APPENDIX D – ALTERNATIVE WELL DESIGN CORRESPONDENCE

Subject: Cabot/Koppers Superfund Site, Gainesville, Florida ("Site")

Revised Floridan Aquifer Monitoring Plan Addendum

Subject: Response to ACEPD Comments in Email Dated March 9, 2006 on the Upper Floridan Monitoring Alternative-Well Design, Koppers Inc. Site in Gainesville, FL

Figure 1. Locations of U.S. EPA required Upper Floridan Aquifer monitoring wells and field determined locations.

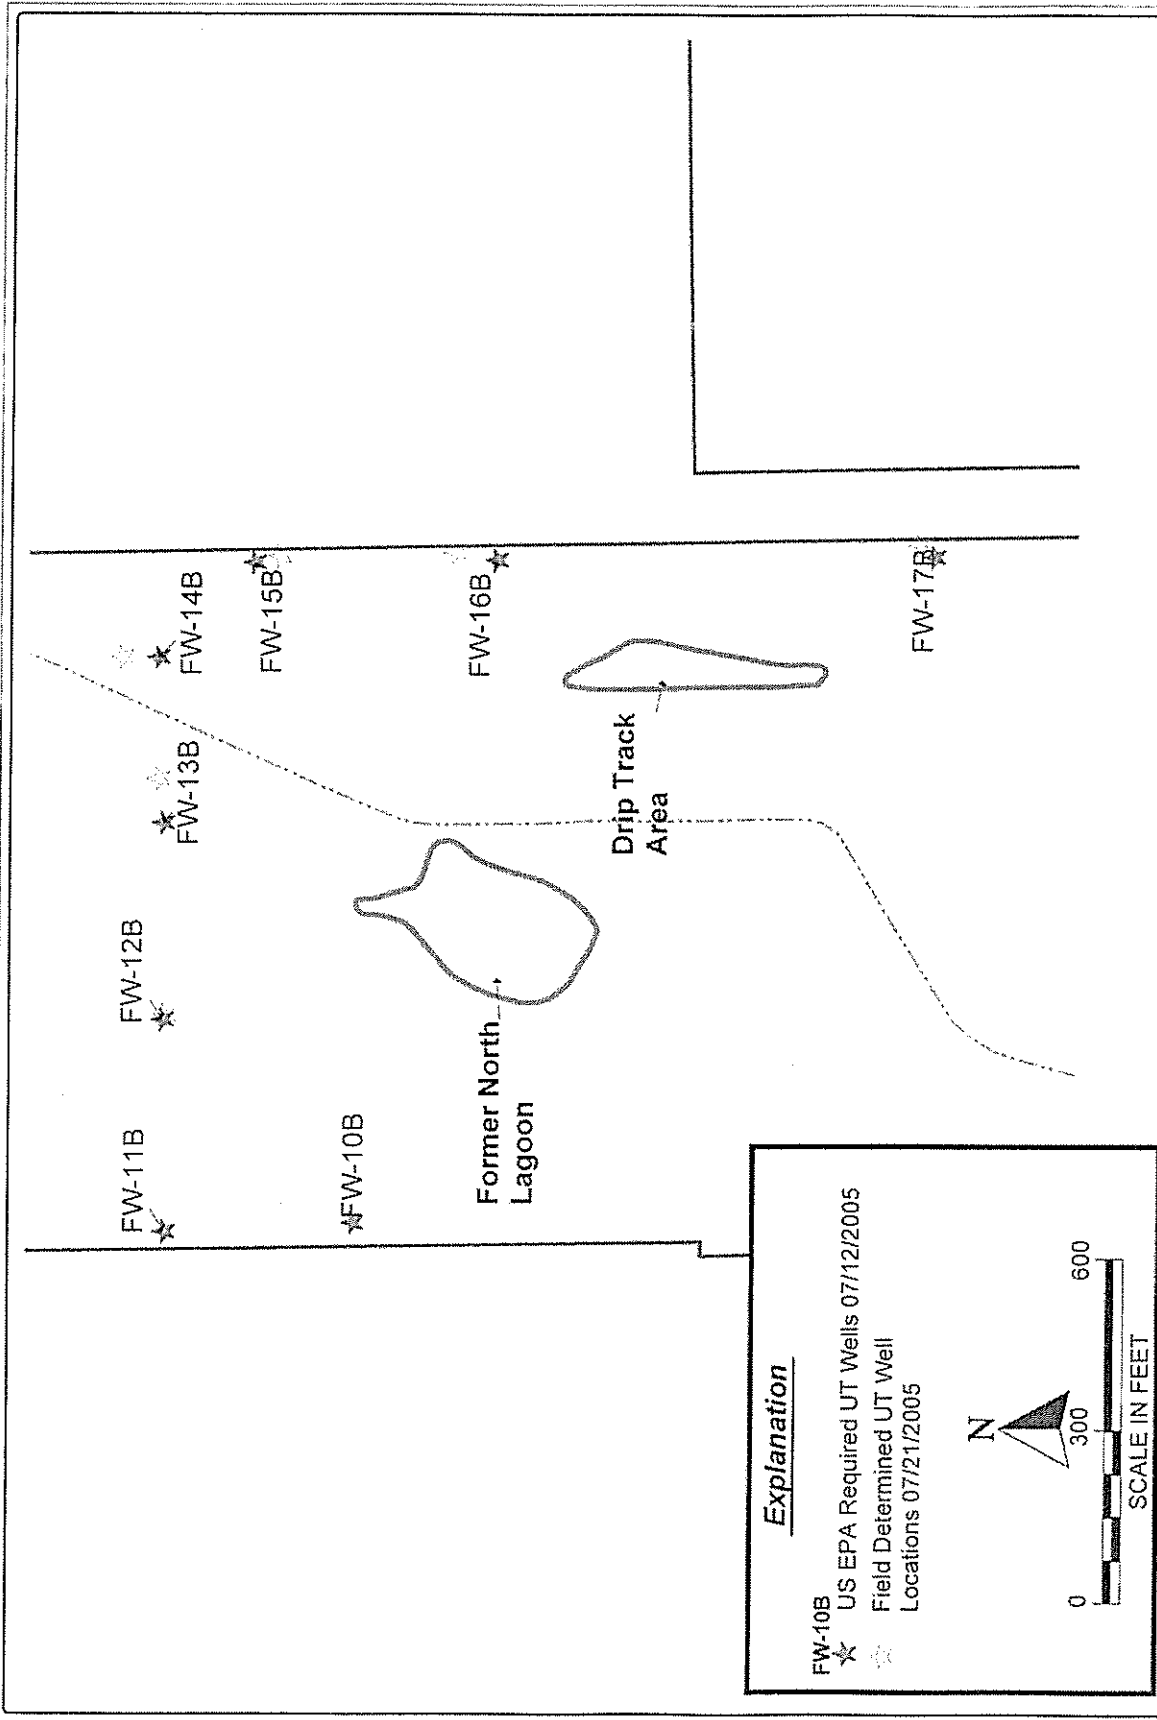
1. Well locations shall be as generally shown on Figure 1.
2. Final well locations shall be agreed upon by stakeholders 7 days prior to starting well construction.
3. Should a well need to be relocated, the following steps shall be completed before commencing with construction of the relocated well:
 - a. Representatives from EPA, GRU, and ACEPD shall be contacted and informed of the field conditions necessitating well relocation.
 - b. Well shall be relocated based on consensus of stakeholders and Beazer.
 - c. Stakeholders shall have 6 hours from initial contact to comment on proposed new locations.
 - d. EPA shall have final authority on relocating a well.
4. The sequence of well completions will be
 - a. Install the eight transect wells
 - b. Install the four source-area wells

Figure 1.
Temporary abandonment design for boreholes
extending into the Upper Floridan Aquifer.

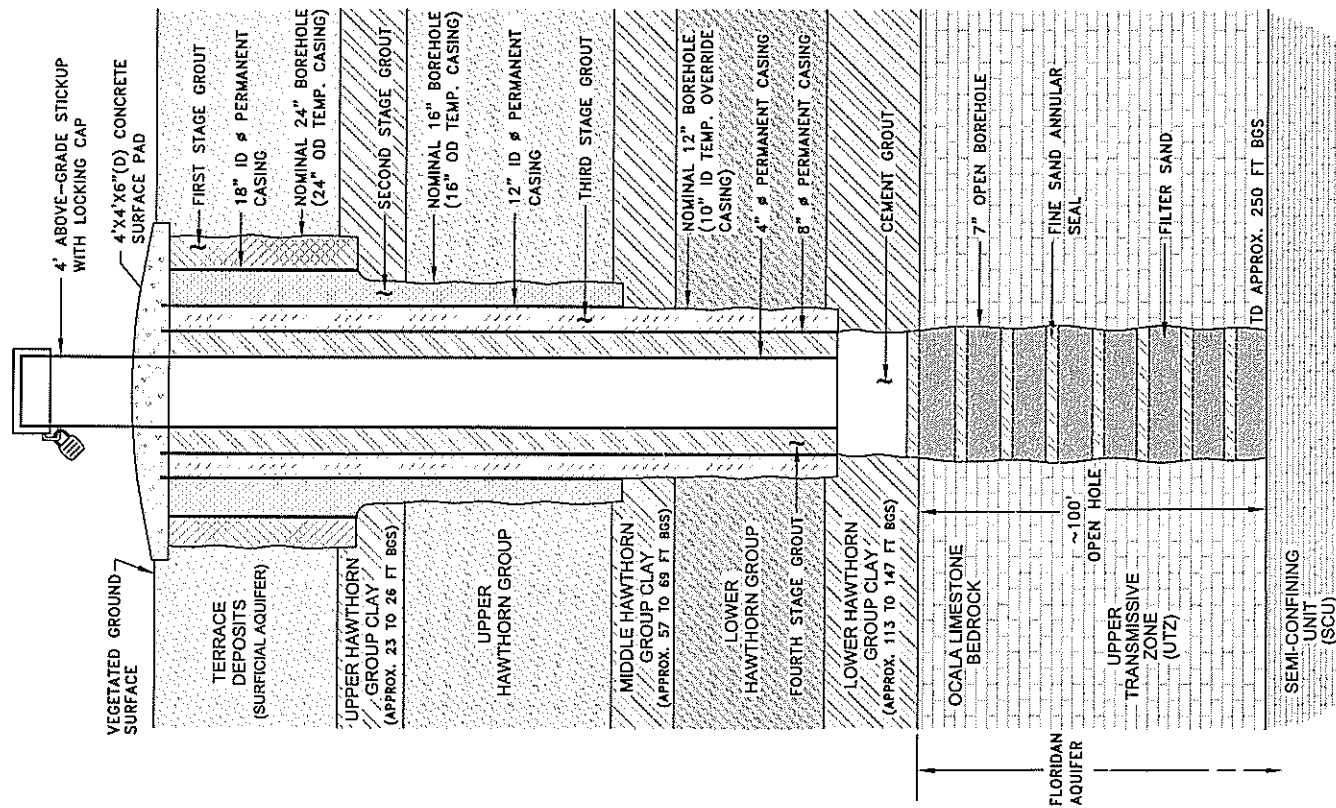
The U.S. EPA letter did not include a discussion of temporary well abandonment procedures for boreholes extending into the UF Aquifer. Figure 1 shows the conceptual design of well abandonment procedures performed for wells FW-10B, FW-12B and FW-14B. The temporary abandonment was performed to prevent vertical migration and mixing within the UF Aquifer, while the alternative well design was developed. The temporary abandonment basically consists of alternating layers of filter sand and low-permeability isolation sand over a 100-ft interval of the UF Aquifer. An approximately 30-ft cement grout plug was placed from the top of the UF Aquifer to the base of the 8" diameter isolation casing to minimize vertical migration within the lower Hawthorn Group clay unit. The abandonment design utilized for the UF Aquifer wells meets the criteria and specifications of the Saint Johns River Water Management District (SJRWMD) (Chapter 40C-3, F.A.C.).

Figure 2.
Proposed alternative quadruple-cased Floridan aquifer well for the Upper Transmissive Zone, with multi-level screens and sampling system.

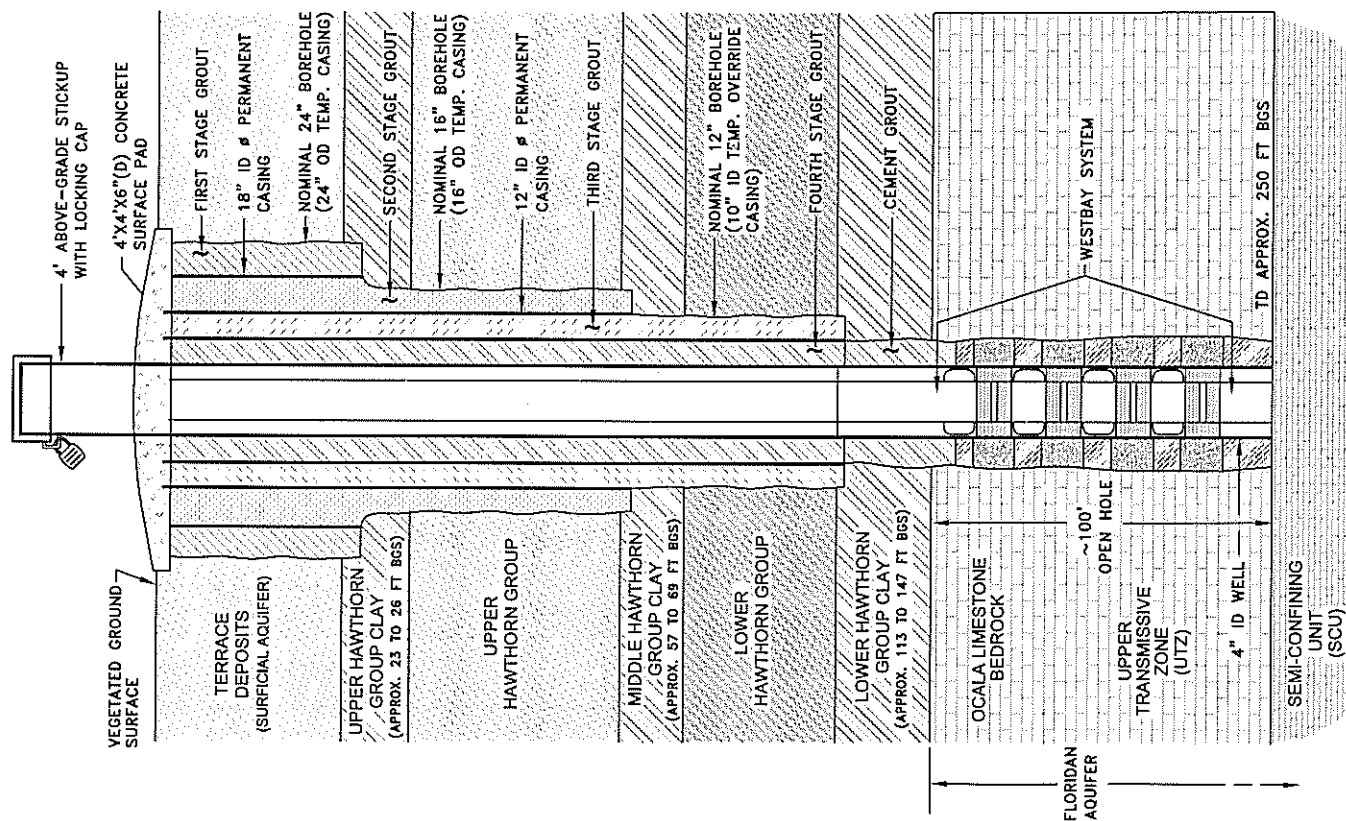
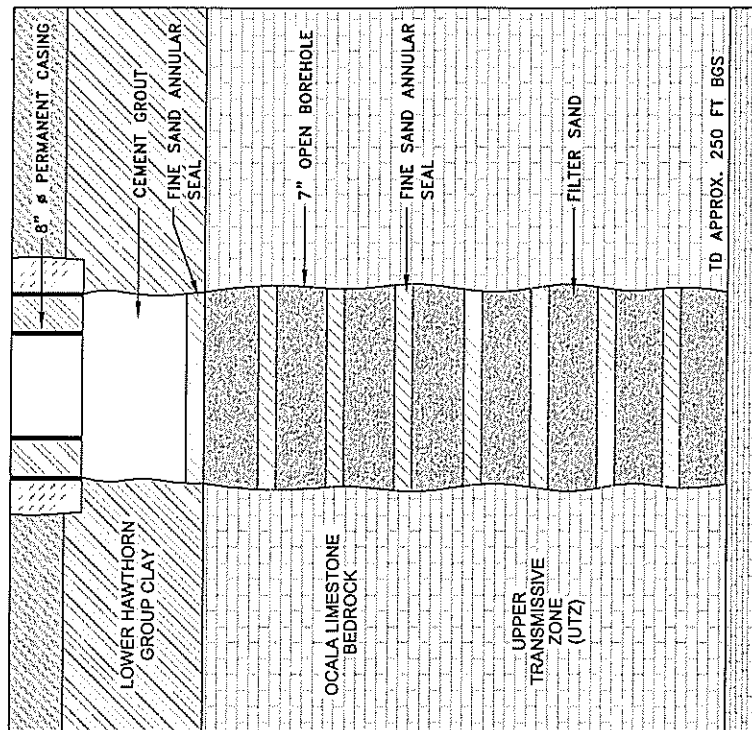
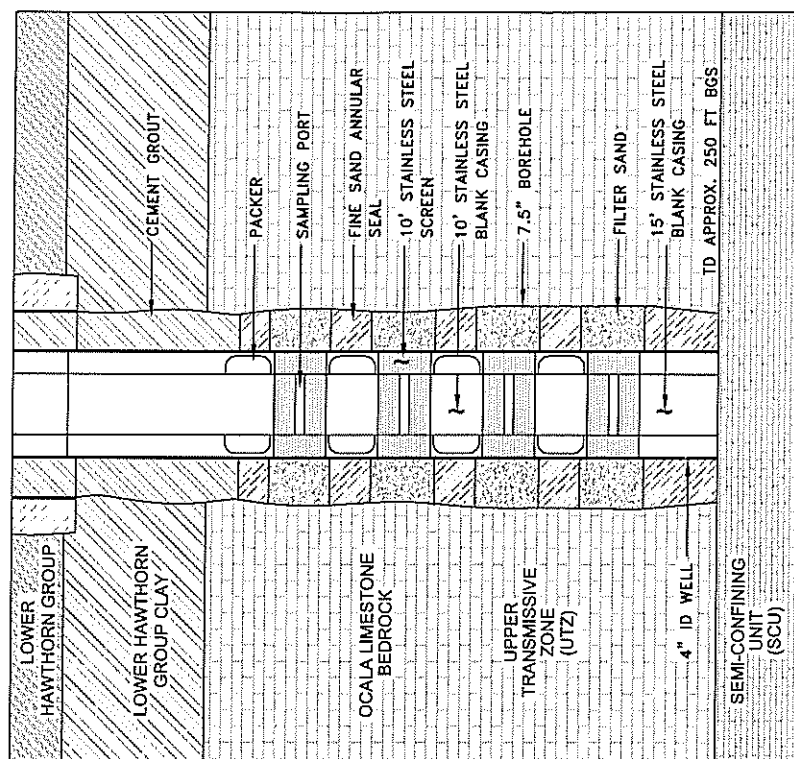
Well construction and logging details for the original well design are discussed in items 1 through 12 in the U.S. EPA letter. The alternative well design will result in modifications to items 5 through 9. Specifically, a nominal 8" diameter borehole will be drilled approximately 100 feet below the top of the UF Aquifer contact. In addition, geophysical logging is not possible for the alternative well design and therefore, will not be performed. A detailed discussion of the alternative well design and procedures are provided below. The conceptual design for an alternative well is shown in Figure 2.

- 1) The primary change to the original well design is the installation of four, 4" diameter, 10-ft well screens in place of the previously proposed open borehole beneath the 4" diameter well casing. The alternative well design will consist of 10-ft stainless-steel, wire-wrapped screens separated from each other by 10-ft of blank stainless-steel casing. Ten-ft well screen intervals are typically used with the Westbay sampling system to allow for the multi-level sampling and purge ports to be approximately centered across the 10-ft screen. A shorter 5-ft screen interval would result in the sampling and purge ports being located on the top and bottom of the screen interval making it more difficult to purge and sample the well. Approximately 15 ft of blank casing will also be installed at the bottom of the well to accommodate the multi-level sampling system specifications and approximately 10 ft of blank casing will be installed across the upper 10 ft of the UF Aquifer to accommodate the installation of annular sealant and grout below the lower Hawthorn Group clay unit. Approximately 40 ft of stainless steel blank casing will extend from the top of the upper screen interval to the base of the 8" diameter black steel isolation casing. The remaining well casing will consist of approximately 110 ft of black steel casing extending to land surface.

- 3) The alternative well design will be constructed the same as the original design, through the installation of the three isolation casings. The only change in the well design will be the installation of the 4" casing. The alternative well design requires that the rotasonic rig advance the 7" nominal diameter override casing to the completion depth of the well (approximately 100 ft into the UF Aquifer). The original well design only had the 7" override casing advancing 5 ft into the UF Aquifer, with a 3.8" borehole extending the remaining 95 ft. The 7" override casing needs to be extended to the completion depth of the well in order to construct the 4" diameter well inside of the override casing. The well construction technique is similar to the construction of a monitoring well inside of a hollow-stem auger. The override casing prevents the unconsolidated deposits from flowing into the borehole during the construction of the well. The alternating blank casing and screens within the UF Aquifer will consist of 15 feet of blank casing at the base of the well, followed by 10 feet of screen and 10 feet of blank casing extending to within 10 feet of contact of the lower HG clay with the UF Aquifer. The top

Please go ahead with ordering well construction materials and with implementing the GeoTrans Upper Floridan Monitoring Well Alternative Design plan, dated October 17, 2005. The plan has been approved by EPA, GRU, ACEPD, and FDEP.
Thank you.
